SUBJECT: NPSH - Report of **SULZER BINGHAM PUMP** (previously Bingham Pump Co.)
 Pump Sales Order No. 270417/418
 Pump Size: **10 x 12 x 14.5 CVDS**
 Monticello (NSP) CORE SPRAY PUMPS

Review and Analysis: by SBP HYDRAULICS GROUP: June 1997 / DLE / RL

<p style="text-align: center;">SUZLER BINGHAM PUMP HYDRAULIC REPORT: 12.5.487 - NPSHR 10 x 12 x 14.5 CVDS PUMPS FOR NORTHERN STATES POWER</p>	<p>Ref: E9710626.DOC TECHNICAL REPORT June 23, 1997</p>	<p>Page 03</p>
-------------------------------------------------------------------------------------------------------------------------------------------------------	-----------------------------------------------------------------	--------------------

CURVE NO.
 58374

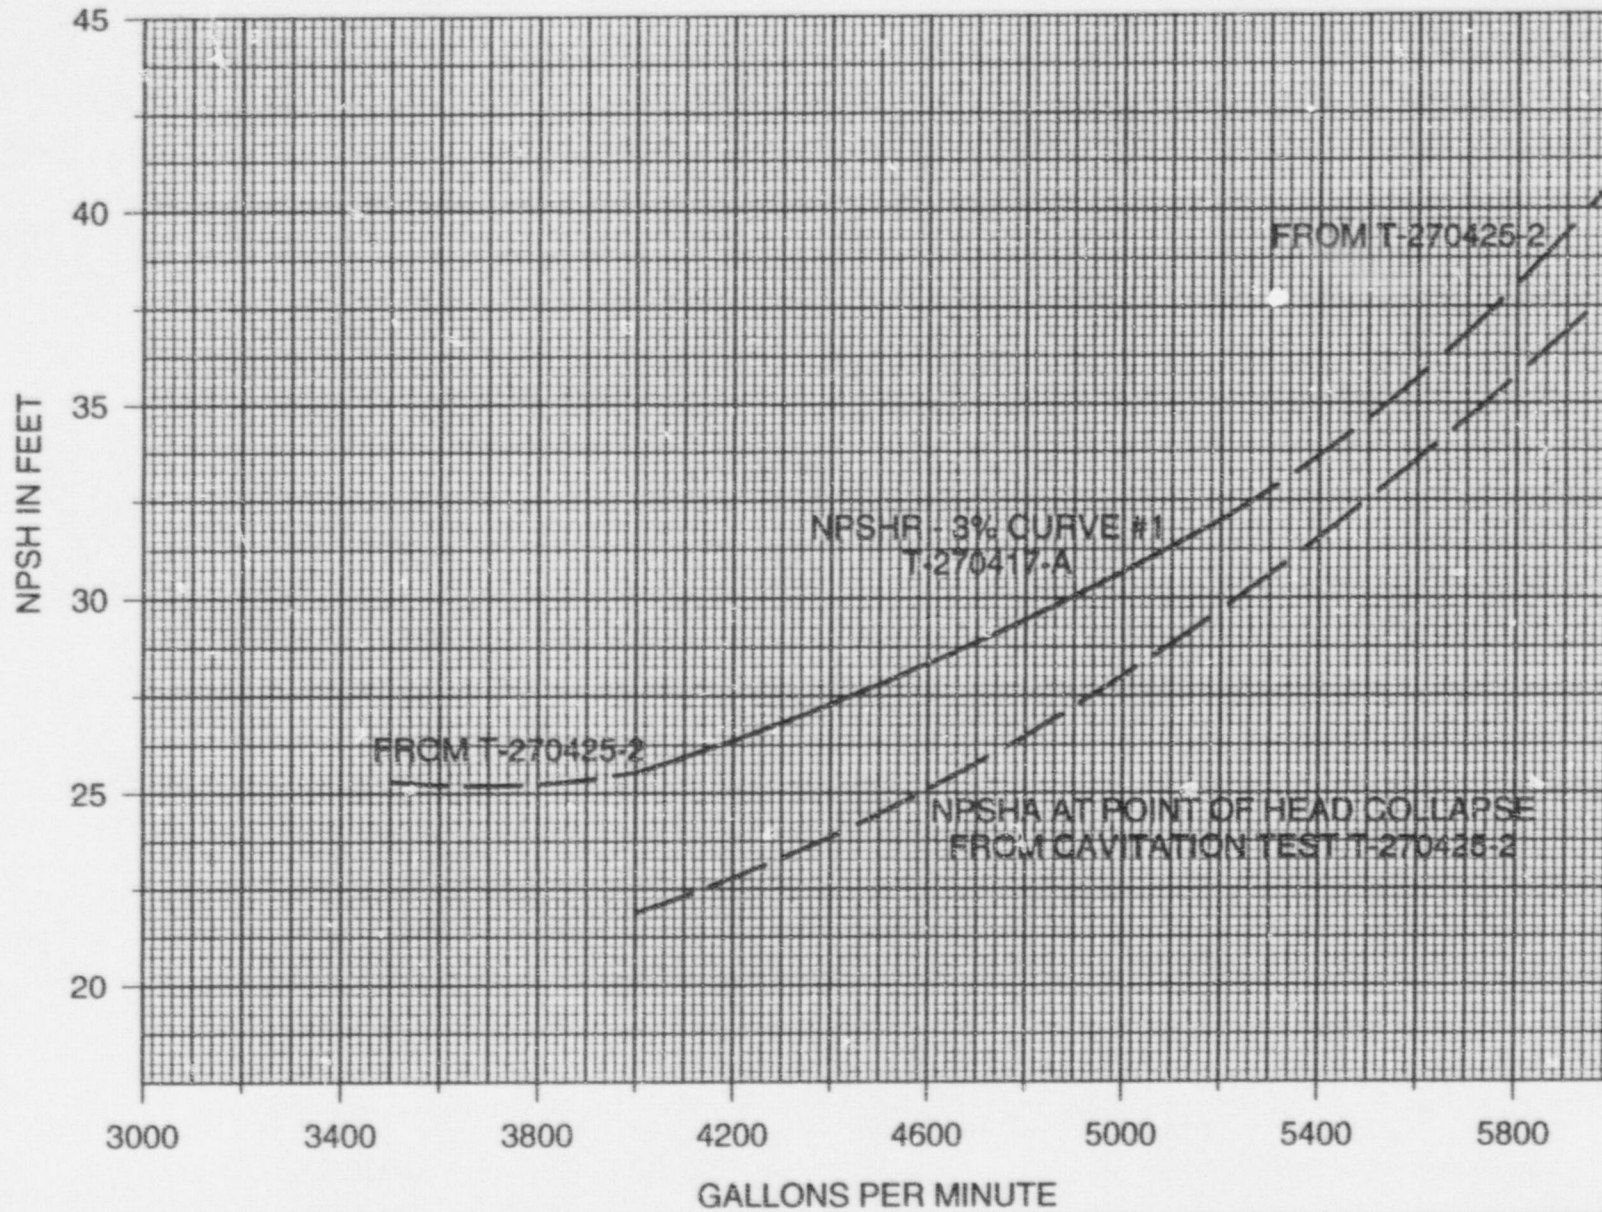
NPSPr shown on Curve No. 26603/604 represents a 1% Head-Drop per NPSH Test T-270417-A for Pump S.O. 270417. See **CURVE #1(58374)** of this report. Also, on **CURVE #1(58374)** are the NPSHr for 3% and 5% Head-Drop respectively. ALL DATA HAS BEEN NORMALIZED TO 3560 RPM.

data and is not the design N_{ss}, which will be a different value based on the B.E.P. @ maximum diameter. Also this value has no tolerance and is subject to variance between pumping units, due to manufacturing processes. See values from **CURVE #1(58374)**. The design N_{ss} would < 14000 based on maximum diameter and including manufacturing and testing tolerances.

Comment: By current standards, this is considered a "High-N_{ss}" impeller design. Pumps of this design have a limited "*perferred operating range*" outside of which increased vibration and internal re-circulation may take place. **CURVE #1(58374)** also identifies the recommended "continuous minimum flow" (greater than (2) two hours operation at this flow in a 24 hour-period). A second, intermittent, minimum flow is also identified. *These values*

CURVE NO.
 58375

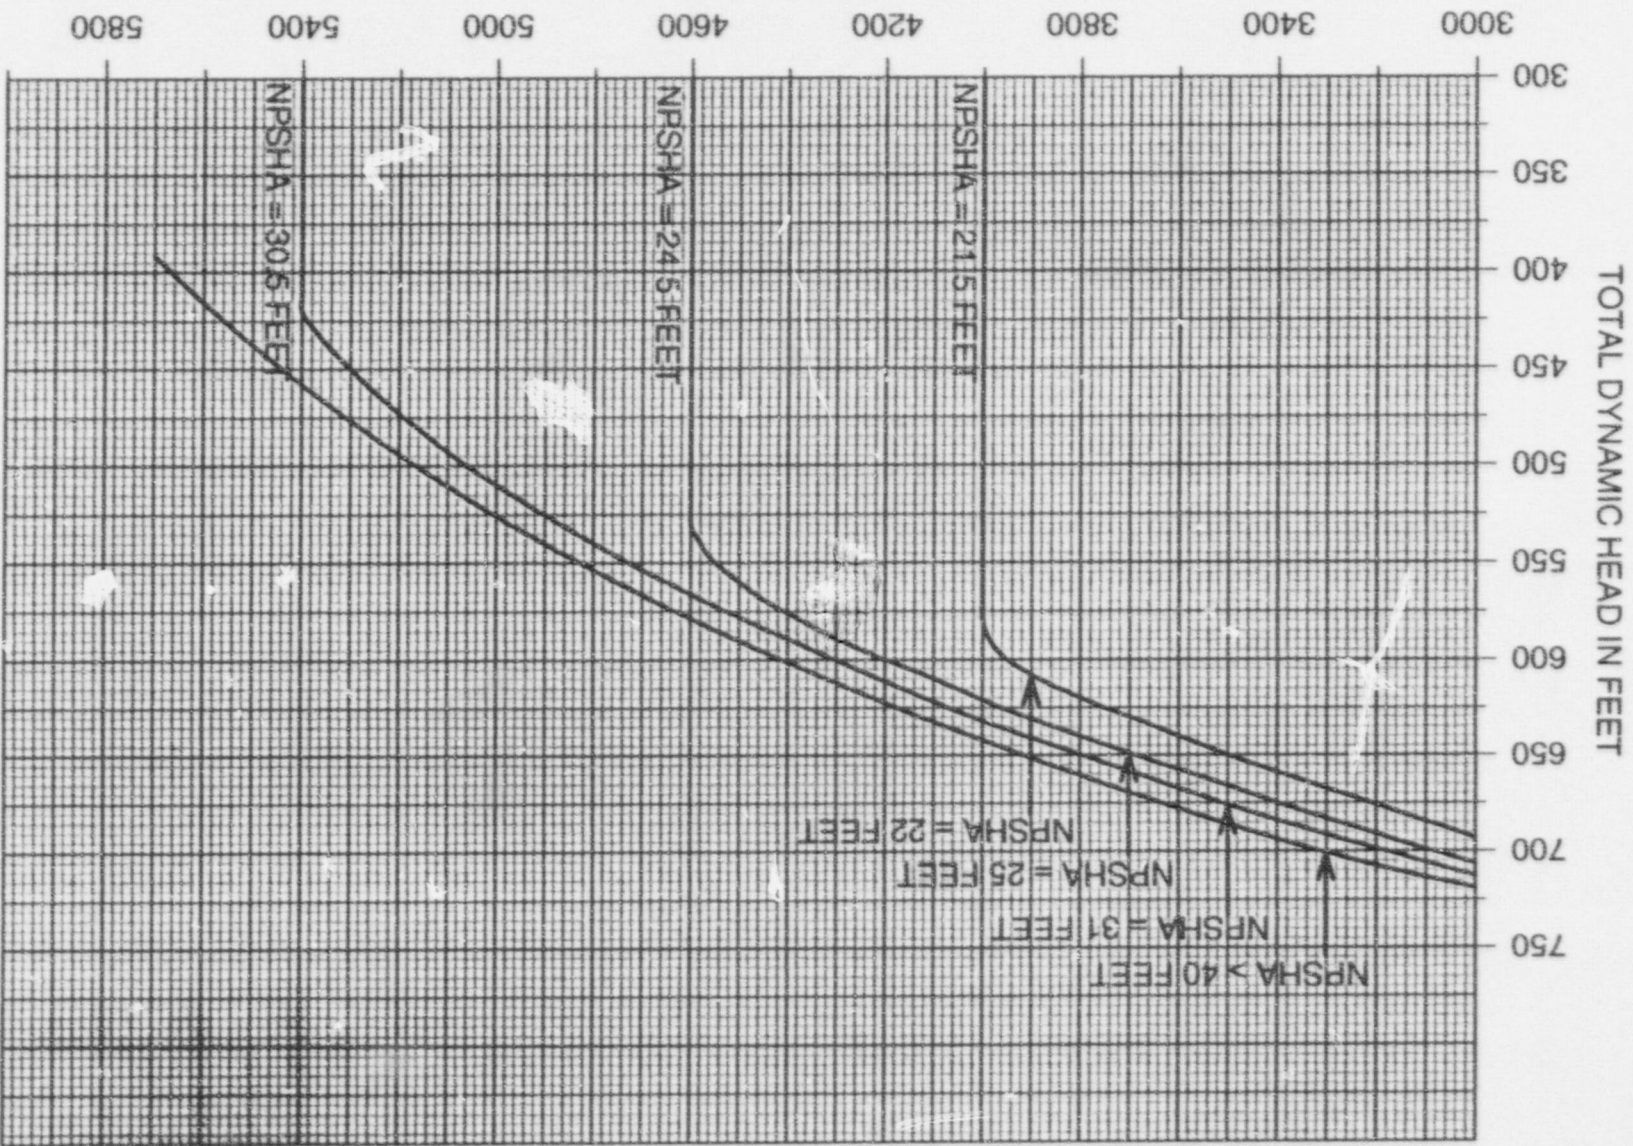
- The NPSHr tests base on 3% Head-Drop performed on S.O. 270425 [12 x 14 x 14.5 CVDS] and S.O. 270417 [10 x 12 x 14.5 CVDS] are identical in the flow regime of 4000 - 5300 GPM. On **Curve #2**(58375) the NPSHr_{3%} values have been added in dotted line from T-270425-2 in the flow ranges of 3500 to 4000 GPM and 5300 to 6000 GPM.

- On Pump S.O. 270425 [12 x 14 x 14.5 CVDS] a Cavitation Test was performed. This test was conducted on May 15 and 16 of 1969. Based on these tests the NPSHa at points of head collapse have been added on **Curve #2**(58375).

Pump S.O. 270425 went through extensive cavitation testing for several hours without visible damage to the impeller, it can be surmised that Pump S.O. 270417/418 will experience similar wear to the impeller when operated for 10 minutes (following a LOCA) at NPSHa values 0.5 feet above head collapse value shown on **Curve #2(58375)** and **Curve #3(58376)**.

CURVE #3

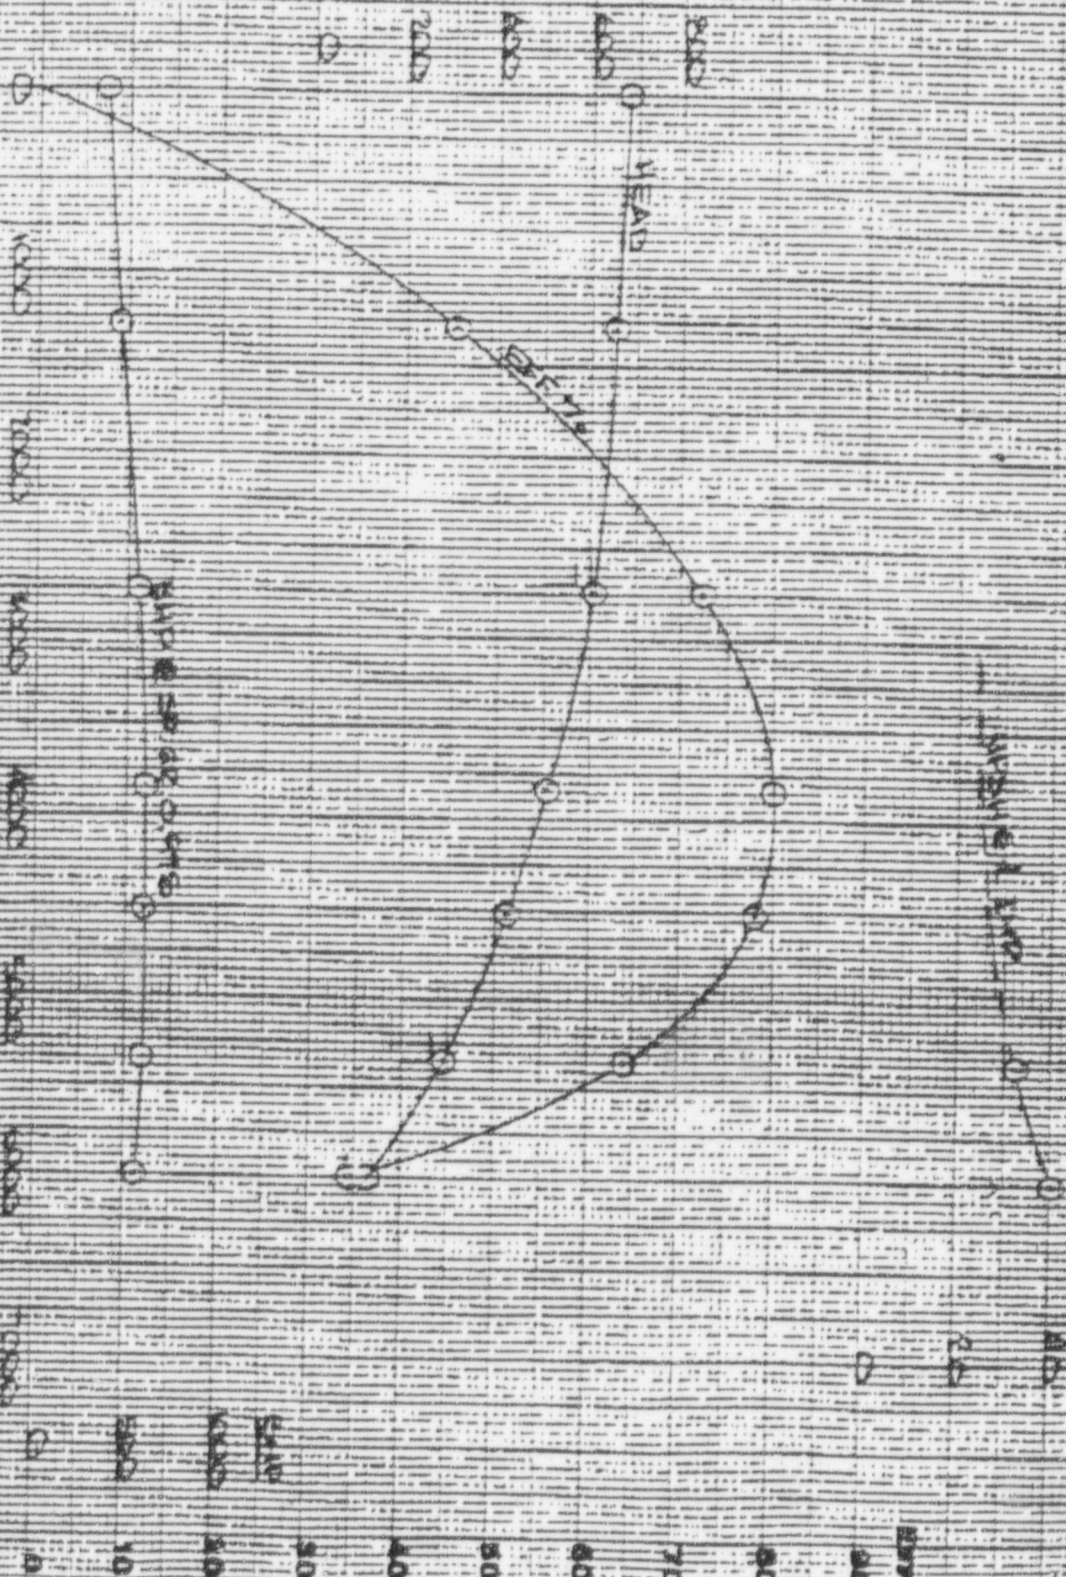
Curve #3(58376), generated from T-270417-A and T-270425-2 provides sufficient data to predict what will be happening to the pump when reduced NPSHa is encountered.
